SILVA|ARCHITECTURE

CLIENT J & K Chappell	DRAWING NUMBER: 25 / 001 - A003	
PROJECT TITLE: Suncot, School Road, Barkham	SCALE:	AS SHOWN @A3
DRAWING TITLE: Existing and Proposed Site Plan	DRAWN BY:	AS
	DATE:	April '25
	REVISION	B

PROPOSED FRONT BOUNDARY GATES
Scale 1:50 @ A3

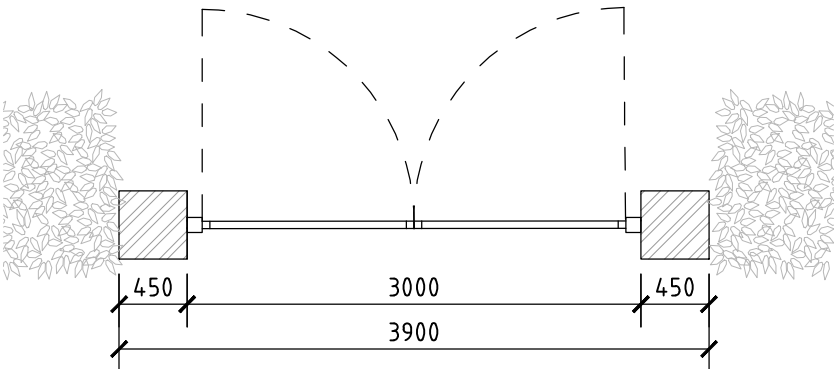
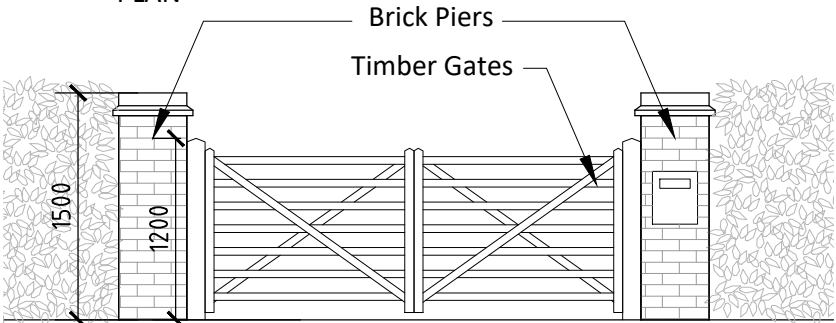
Rev:	Date:	Notes:
A	22.10.25	Revised to retain more of the existing walls.
B	11.12.25	Revised to relocate gates 5m from carriageway as requested by Highways.
